Bid Bulletin #02

PROJECT: Gateway Early Childhood Center
Bid Package #4
Omaha, NE

ADDENDUM E

Gateway Early Childhood Center
Omaha, Nebraska
RDG Project No. 2014.129.00, File 35.1

B1 TYP. SECTION - STEEL SECURITY BOLLARD - ADD-E
 1/2" = 1'-0"

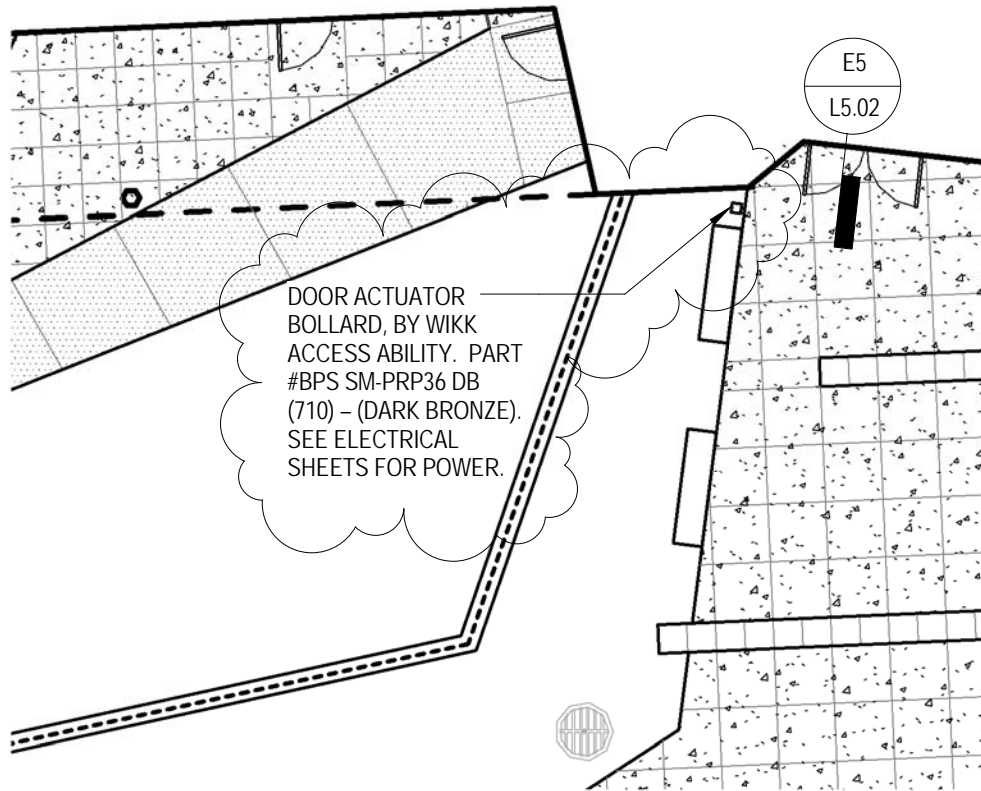
- A. Added actuator bollard at front entrance per attached Supplemental Drawing SDL-002.
- B. Updated legend per attached Supplemental Drawing SDL-003.

A2 SOUTH ELEVATION
1/8" = 1'-0"

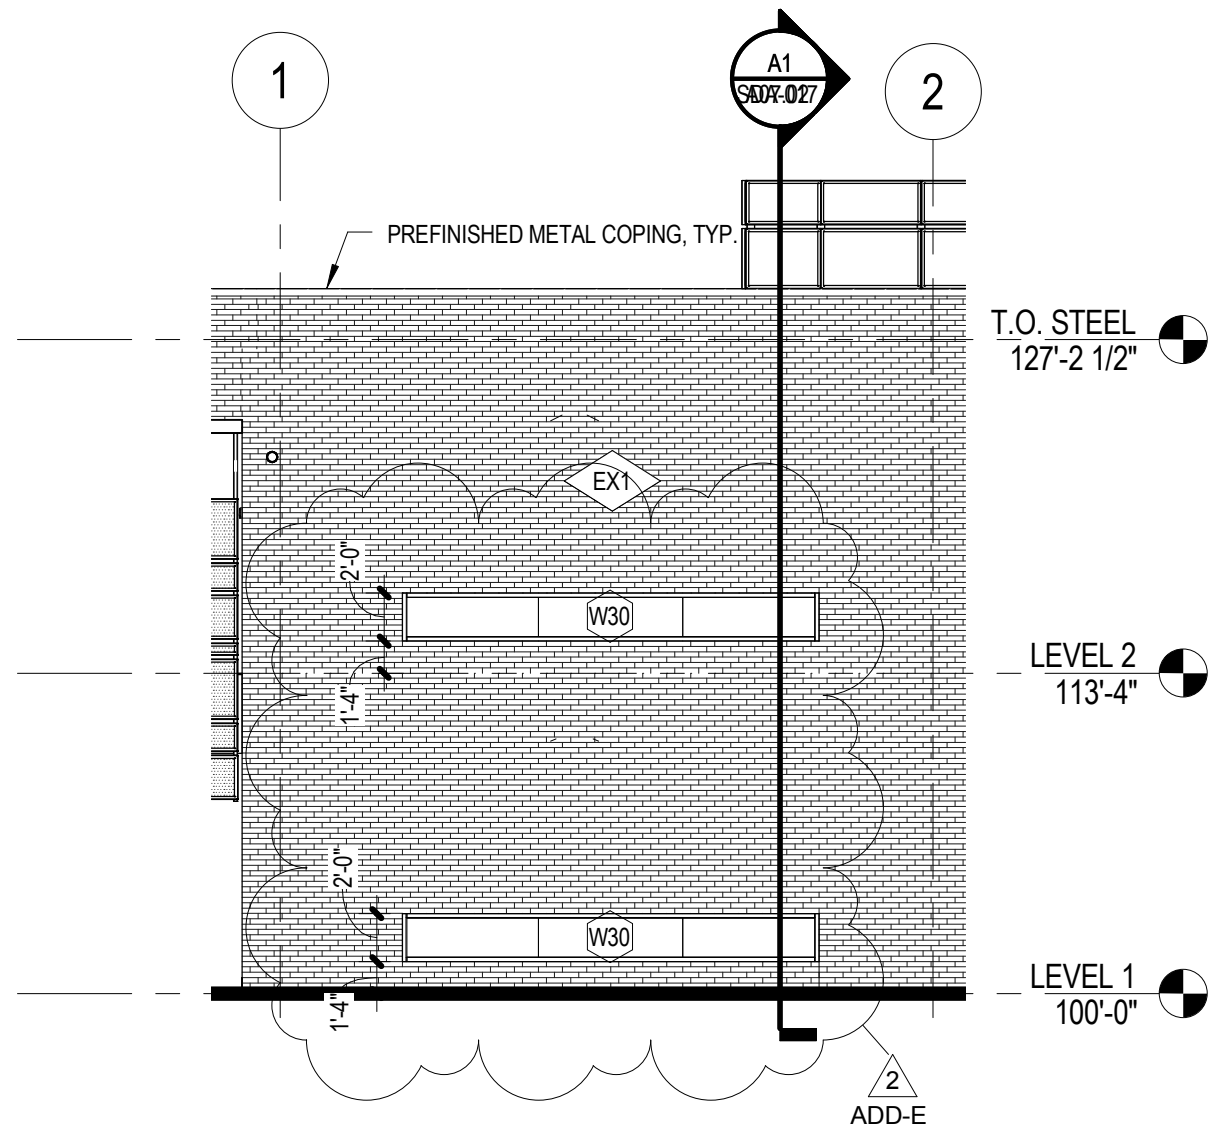
- A. A2 – “South Elevation,” Two W5 Windows Located between Column Lines 1 and 2:
 - 1. Modify window tag from W5 to **“W30.”**
 - 2. Modify height of these windows from 1’-4” to **2’-0”**.
 - 3. Modify height above finish floor of these windows to **1’-4”**.
- B. B2 – “North Elevation,” W5 Window Located between Column Lines 1 and 2:
 - 1. Modify window tag from W5 to **“W30.”**
 - 2. Modify height of this window from 1’-4” to **2’-0”**.
 - 3. Modify height above finish floor of this window to **1’-4”**.
- C. D4 – “West Elevation:” Brick veneer expansion joints indicated.

A1 WALL SECTION
3/4" = 1'-0"

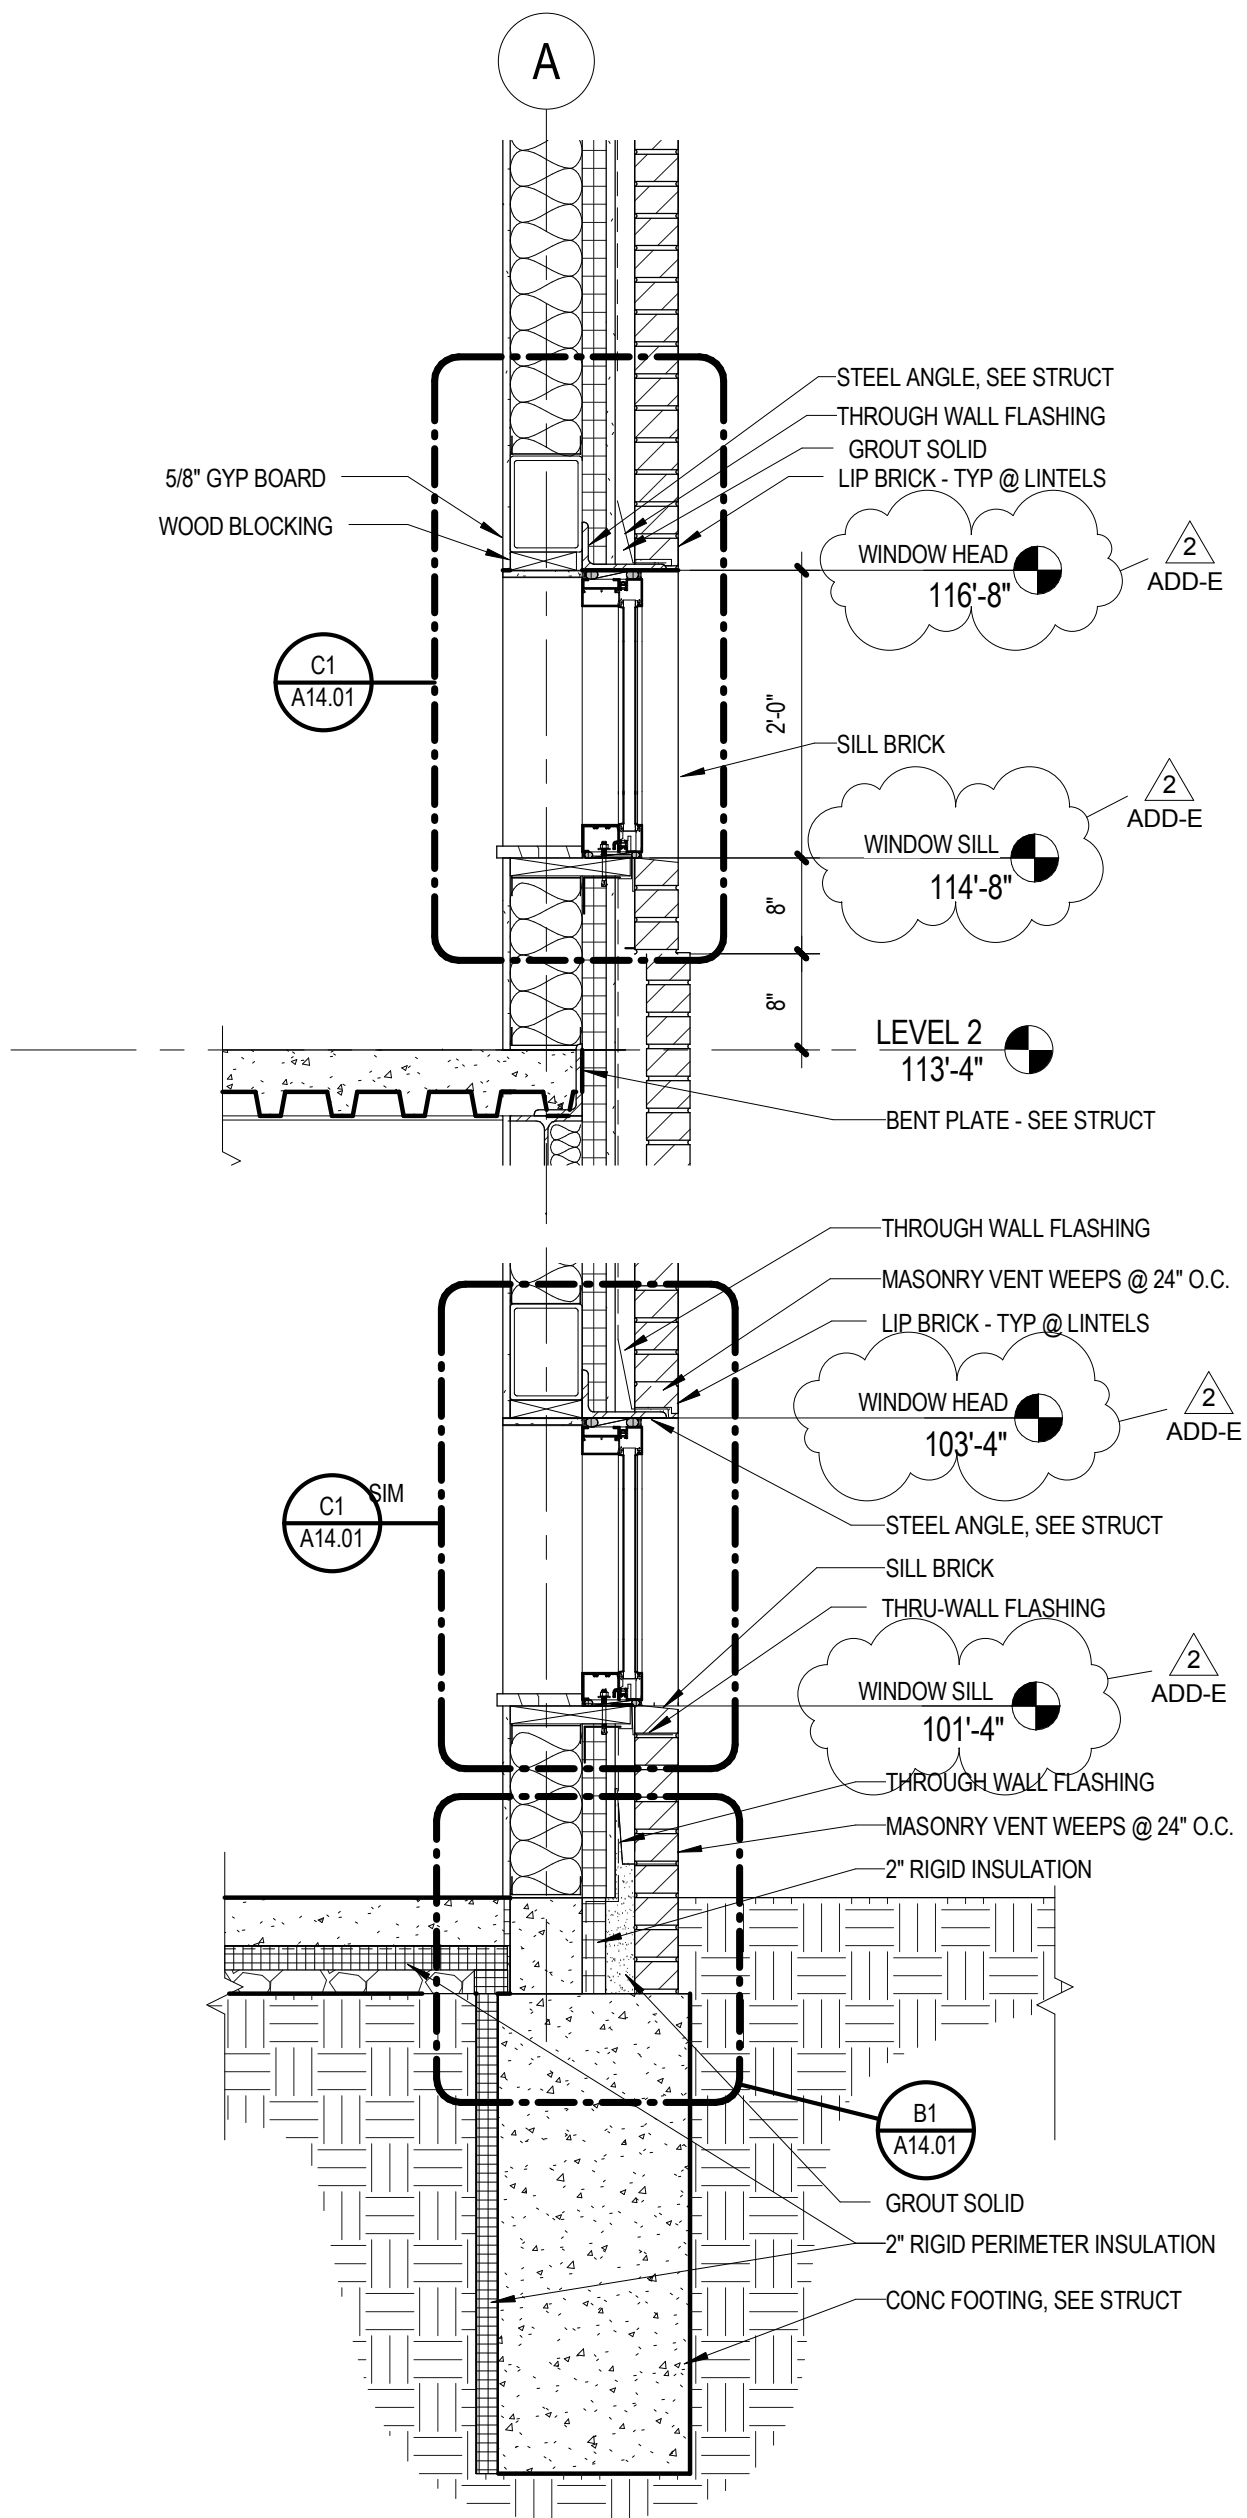
- A. Disregard brick stepping shown on wall sections; refer to Sheet A05.03 brick banding elevations for location and depth of stepped brick.
- B. At Wall Section A1, modify sill and head elevations as indicated on attached Supplemental Drawing SDA-017.

Project Number:	2014.129.00	Date:	12/03/14	Change to Sheet:	A10.02	Drawing:	SDA-018
	GATEWAY EARLY CHILDHOOD CENTER							
ADD-E

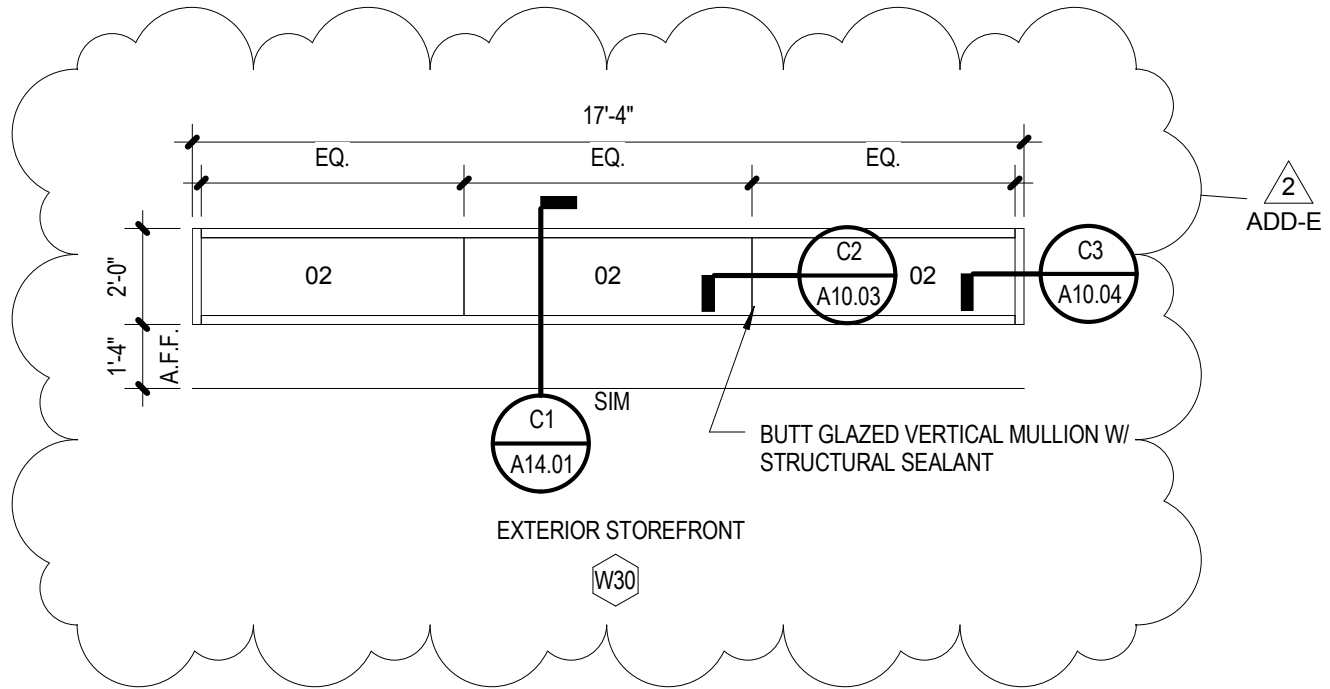
- A. Add Window Elevation **“W30”** to correspond to change in size of three windows previously called out as “W5.” See attached Supplemental Drawing SDA-018.
- B. Add new Window Elevation **“W31”** as shown in attached Supplemental Drawing SDA-023.

STAIR GATE JAMB DETAIL

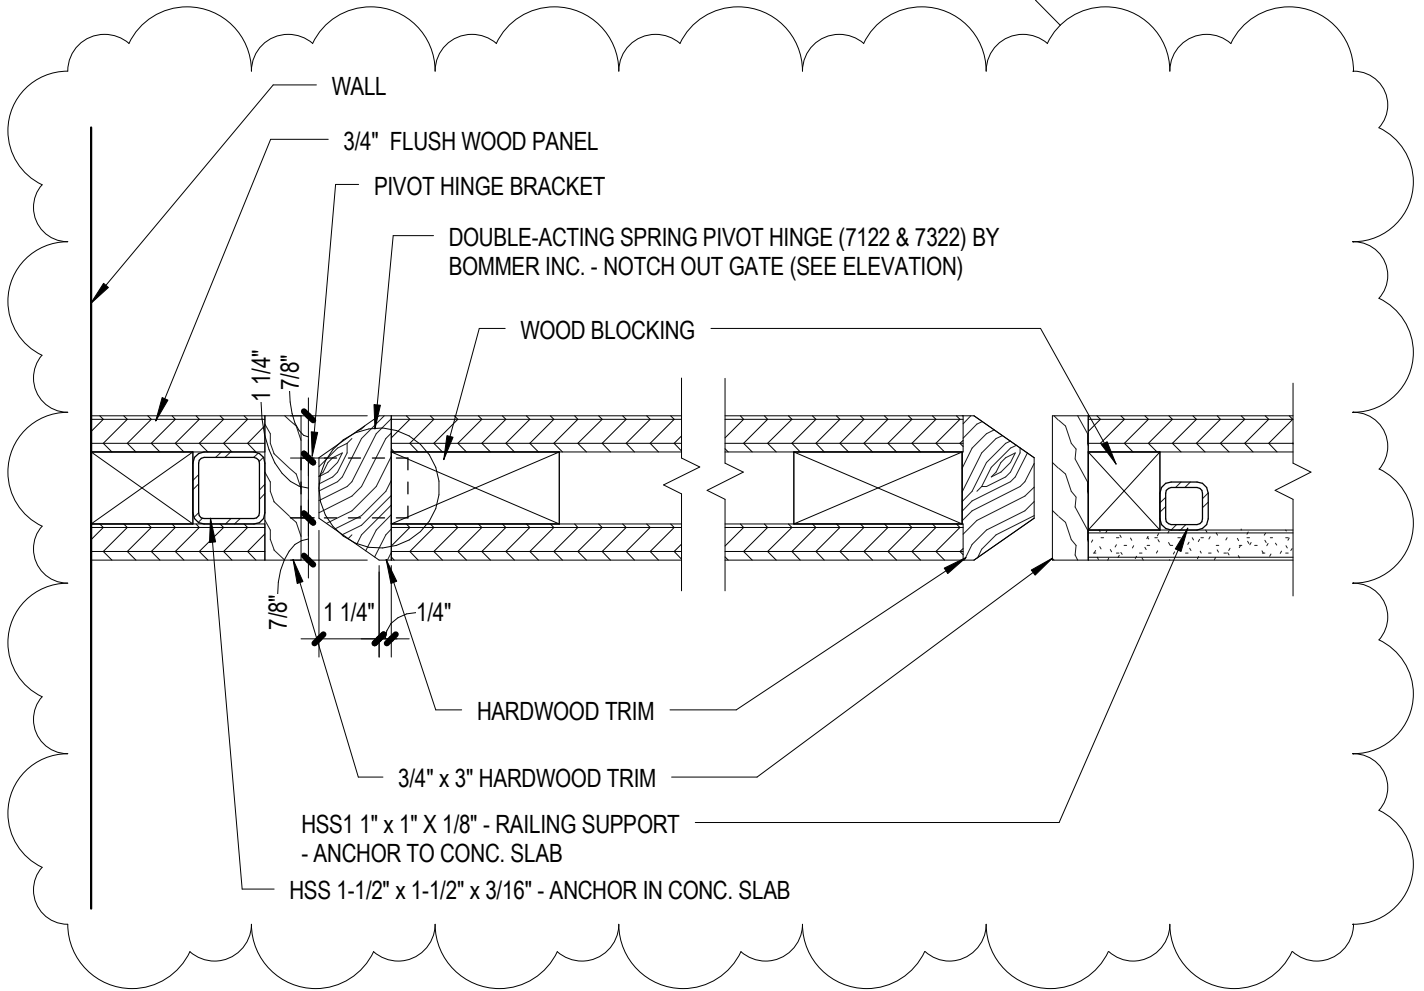
- A. Revise Section C1 per attached Supplemental Drawing SDA-020.
- B. Add new Stair Gate Jamb Detail B1 per attached Supplemental Drawing SDA-021.

Project Number: 2014.129.00 | Date: 12/05/14 | Change to Sheet: A10.05 | Drawing: SDA-022

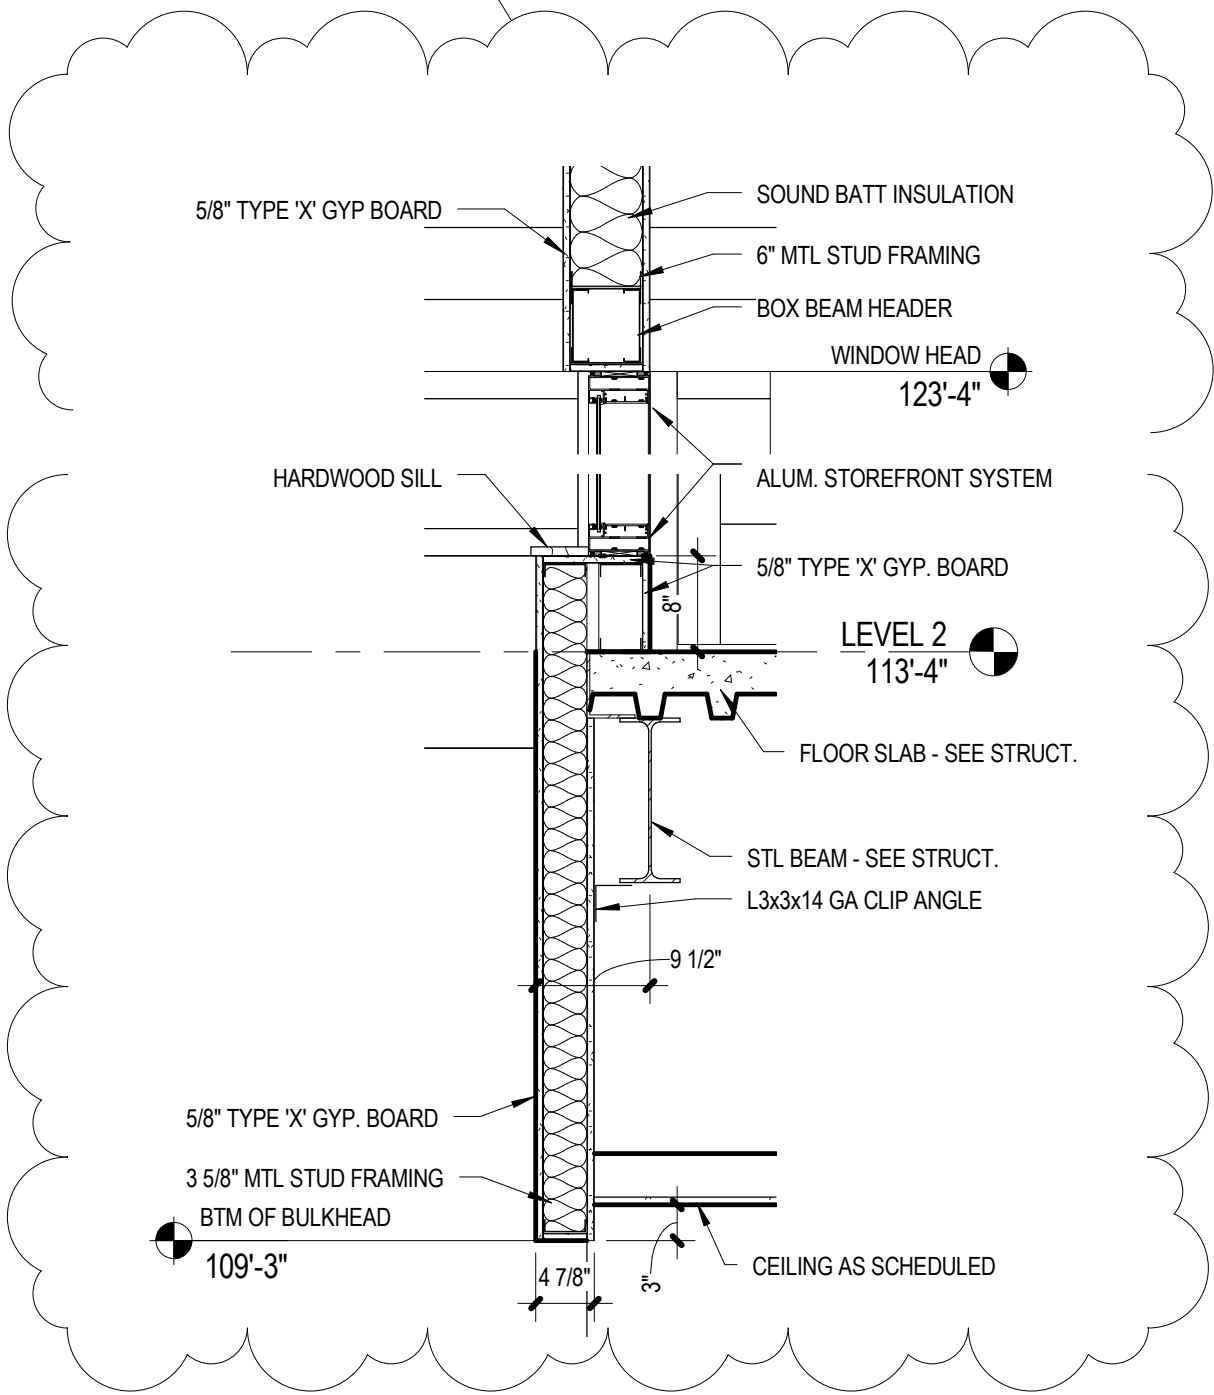
Sheet A10.05 – Door/Window Details: Add new Window Head/Sill Detail C6.1 per attached Supplemental Drawing SDA-022.
